Notice of Allowability

10/709,944

EXAMINER'S AMENDMENT

Fig. 1P

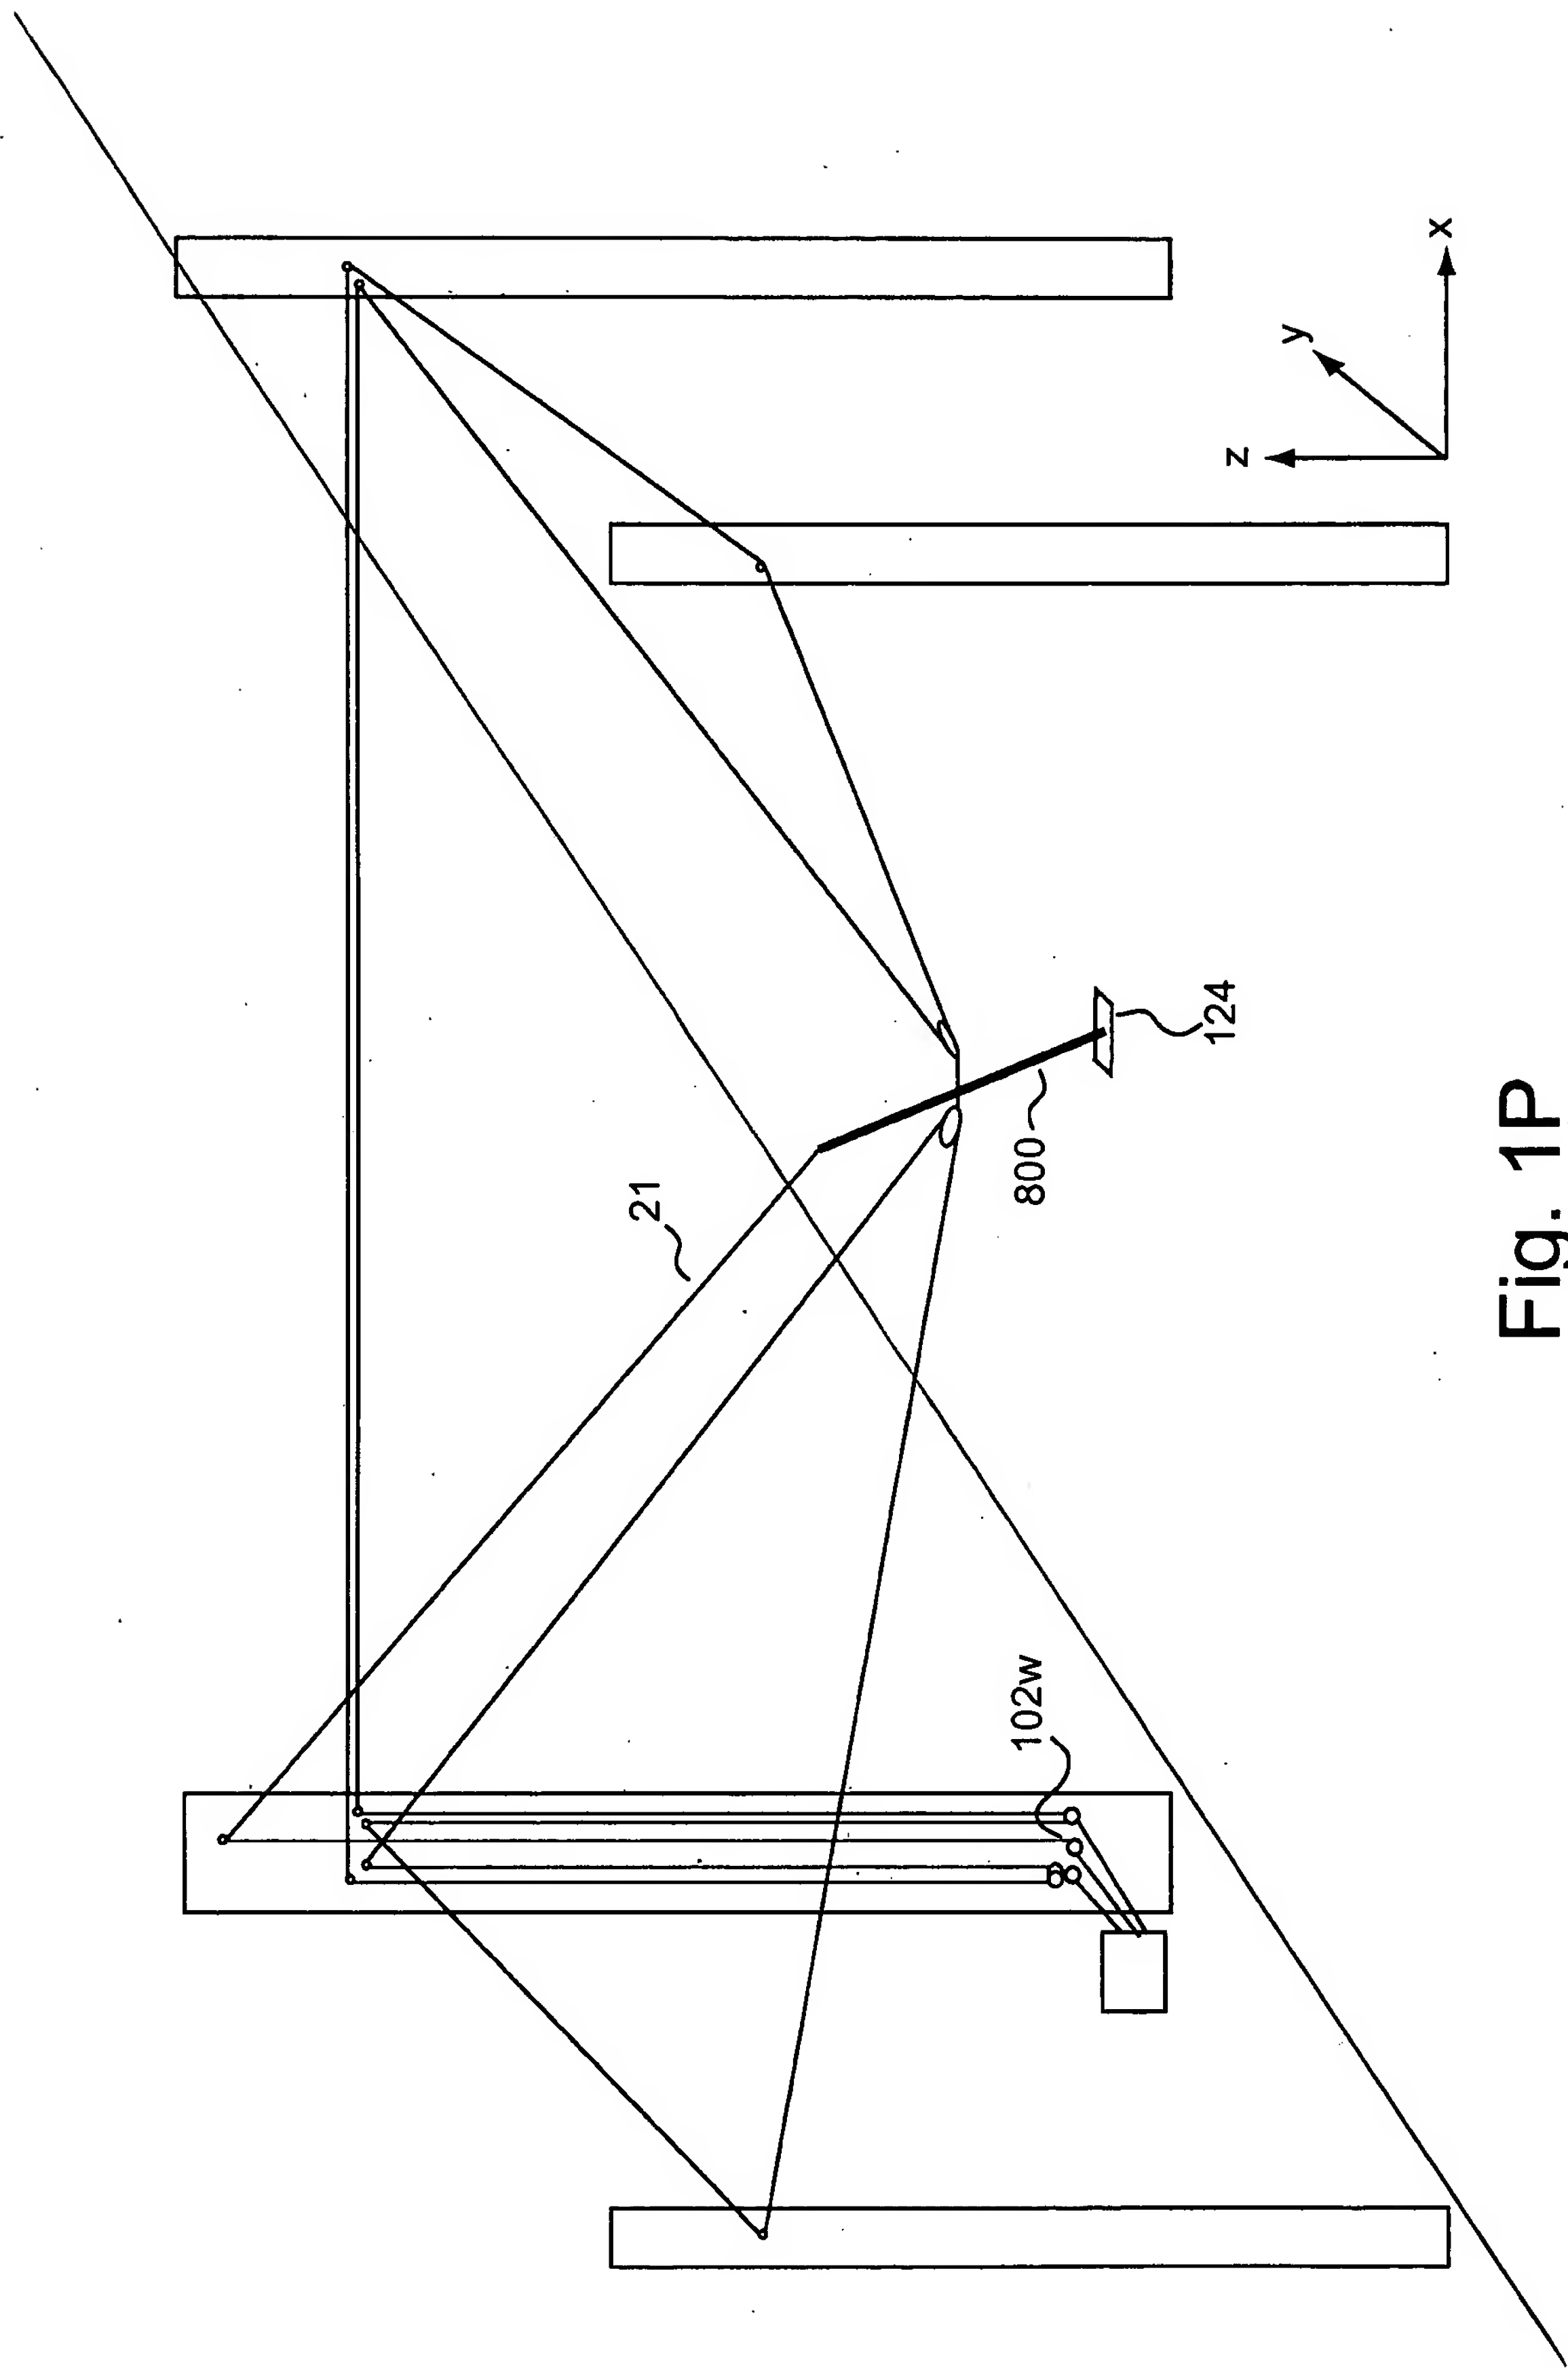
In the specification, paragraph [0130], line 1, change "Figure 1P" to --Figure 13--.

In the drawing, delete Fig. 1P.

In the specification, paragraph [0130], line 1, change "Figure 1P" to --Figure 13--.

In the drawing, delete Fig. 1P.

Delete Fig. 1P.

2. Applicant must submit a new sheet of formal drawing Fig. 13. The new sheet of formal drawing Fig. 13 must be labeled as "New Drawing Sheet" or "New Sheet".

2. Applicant must submit a new sheet of formal drawing Fig. 13. The new sheet of formal drawing Fig. 13 must be labeled as "New Drawing Sheet" or "New Sheet".
